MEMORANDUM

SUBJECT: Consider Approval of the Maplewood Alzheimer's Special Care Center, 1700 Beam Avenue

1. Design Review
2. Parking Waiver

Engineering Plan Review**PROJECT: Maplewood Alzheimer's Special Care Center****PROJECT NO: 16-33****COMMENTS BY: Jon Jarosch, P.E. – Staff Engineer****DATE: 10-31-2016****PLAN SET: Engineering plans dated 9-28-2016****REPORTS: Storm Water Management Report – Dated 9-16-2016**

PLANTING PLAN

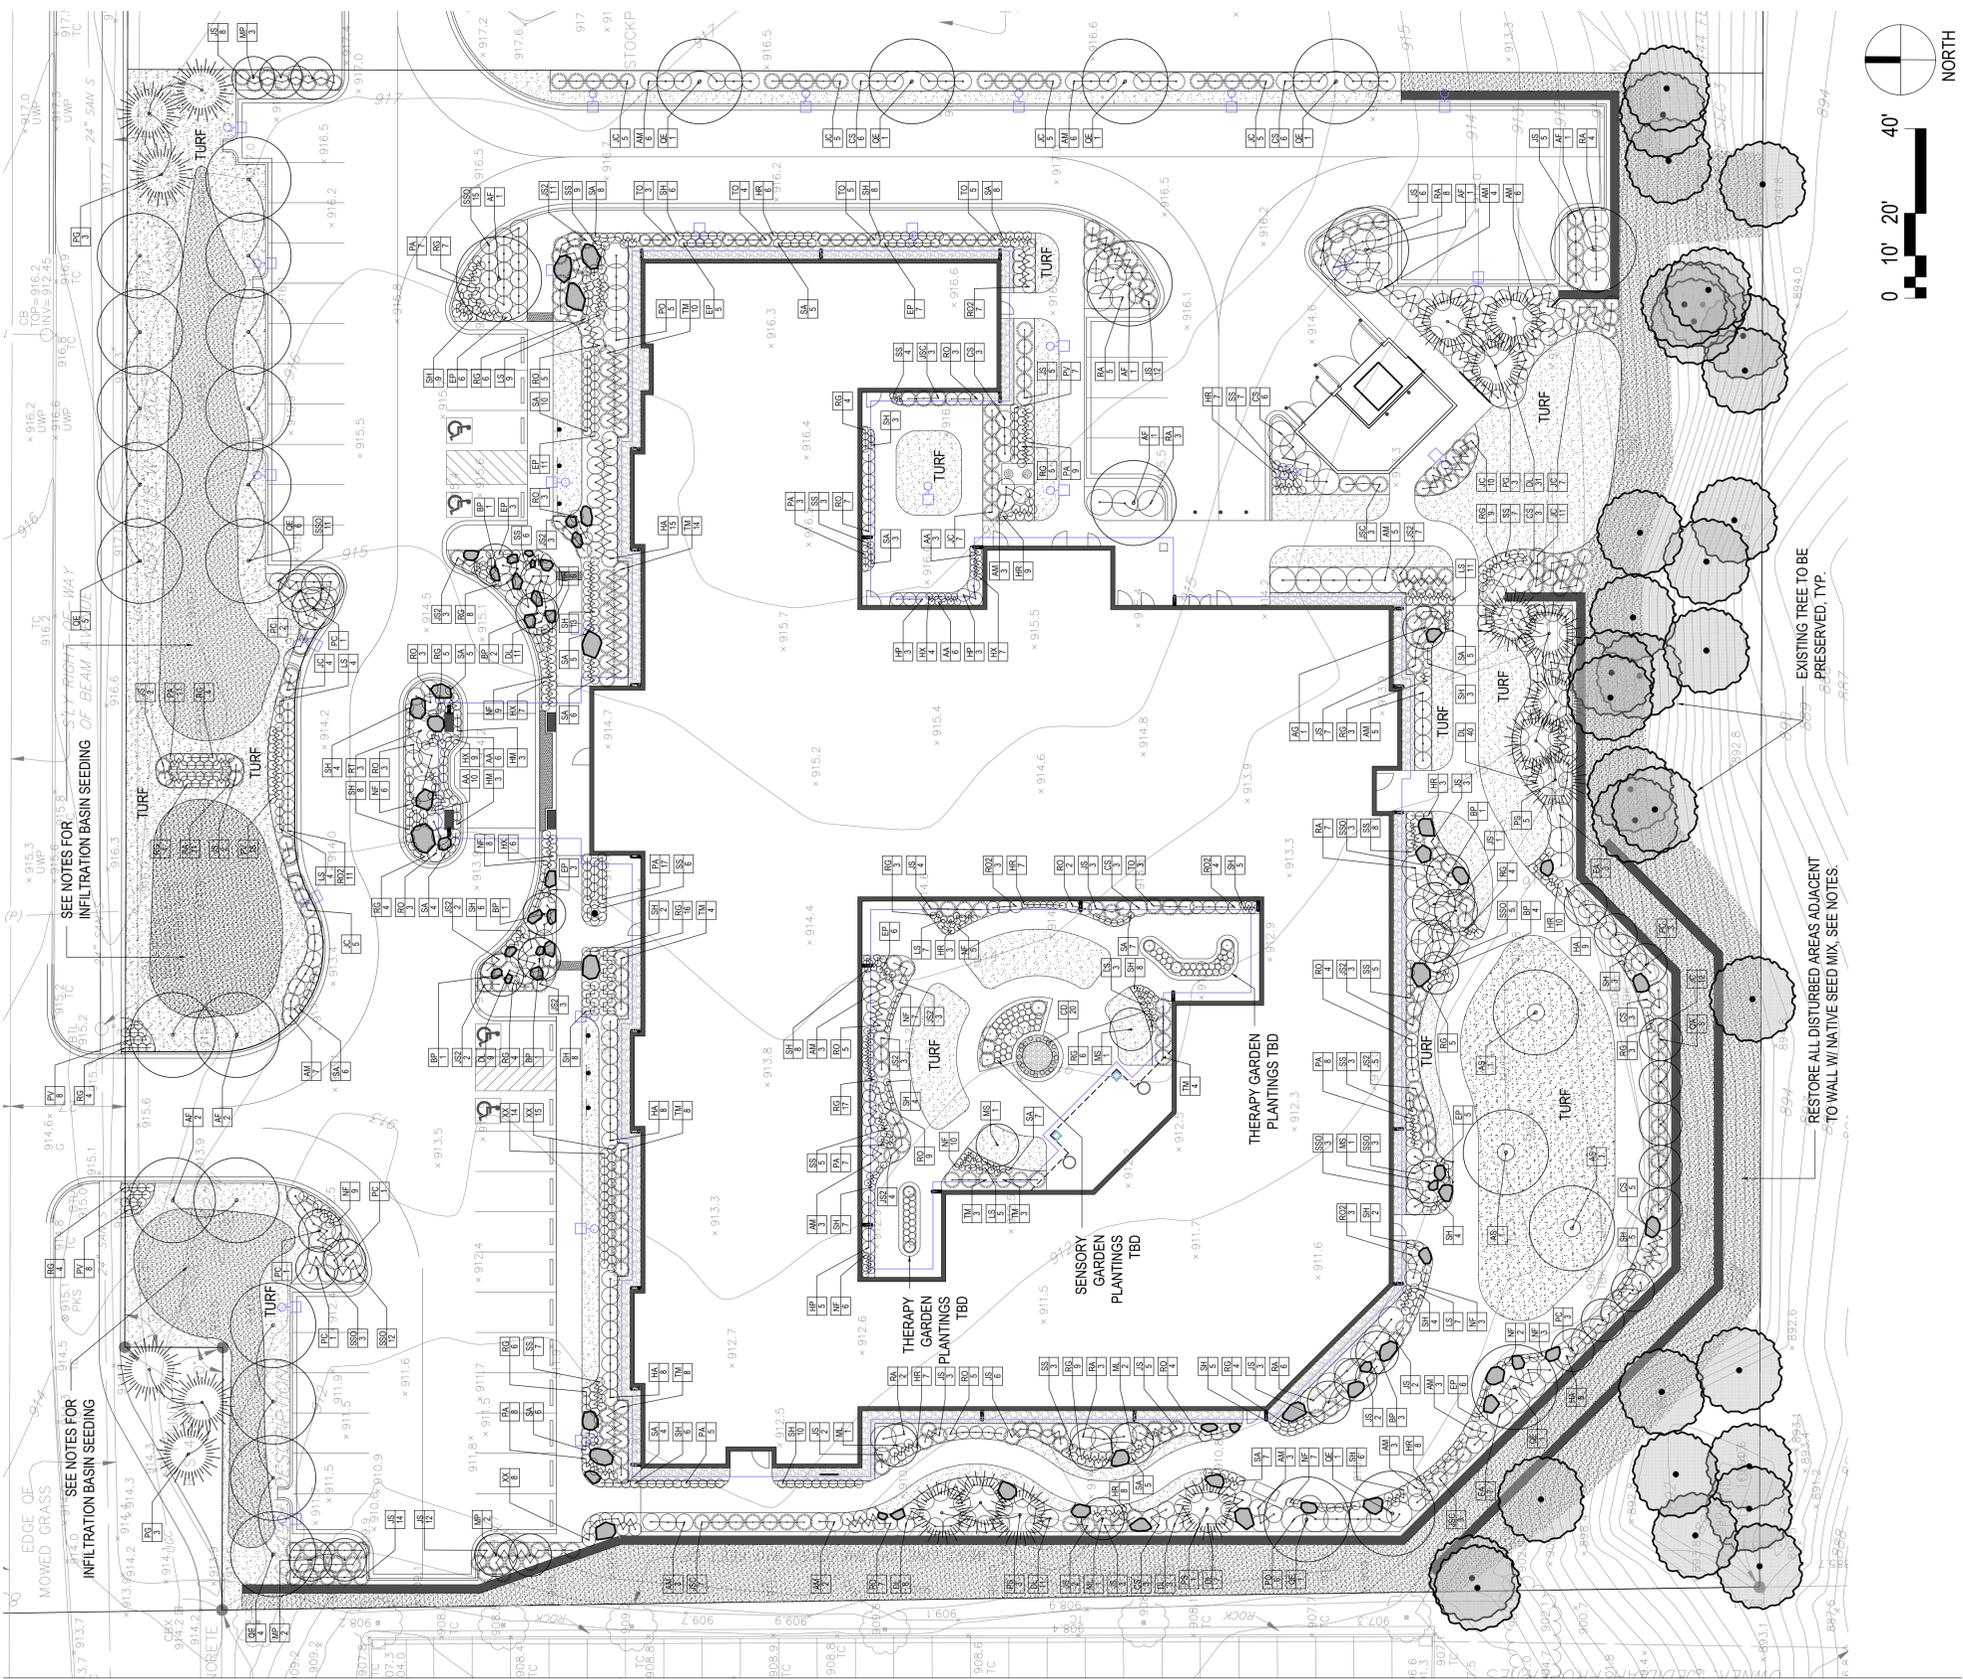
Trees: To construct this project, the applicant intends to remove 35 significant trees – a total of 629.5 diameter inches. Several large trees are being preserved along the south side of the property, adjacent the City open space. Based on the city's tree preservation ordinance the applicant is required to plant 64.05 caliper inches of trees, or 32 – 2-inch trees. The applicant's planting plan shows 98 new trees being planted – with a total of 266 caliper inches, exceeding the City's tree replacement requirements. Additional tree replacement details can be found on the November 8, 2016, environmental review attached.

Overall Landscaping: The planting plan is attractive and substantial, with oversized trees and shrubs being proposed throughout the property.

- c. **Tree Preservation Recommendations:**
 1. Submit a revised tree mitigation plan which reflects the accurate tree mitigation/replacement calculation (adopted as part of the December 2015 tree preservation ordinance). This calculation allows a credit for specimen trees preserved as part of the development ($A = \text{total diameter inches of significant trees lost}$, $B = \text{total diameter inches of significant trees on the lot}$, $C = \text{tree replacement constant (1.5)}$, $D = \text{total diameter inches of specimen trees preserved}$, $E = \text{required replacement trees}$; $((A/B - .20) \times C) \times A - (D/2) = E$). The applicant used the City's previous tree replacement calculation that did not include the specimen tree credit.

2. Submit a tree preservation plan which shows how the trees scheduled to be preserved will be protected during development per the City's tree standards.

- c. Infiltration Basin Recommendations:
1. Provide a landscape plan for each infiltration basin, including a list of species, container size, spacing, and quantities to be approved by City staff.
 2. For any area using a native seed mix (ex: pond slopes), provide information on maintenance for planting year and years two and three, addressing what maintenance activities will be required and what entity (developer, owner, etc.) will take on this responsibility.
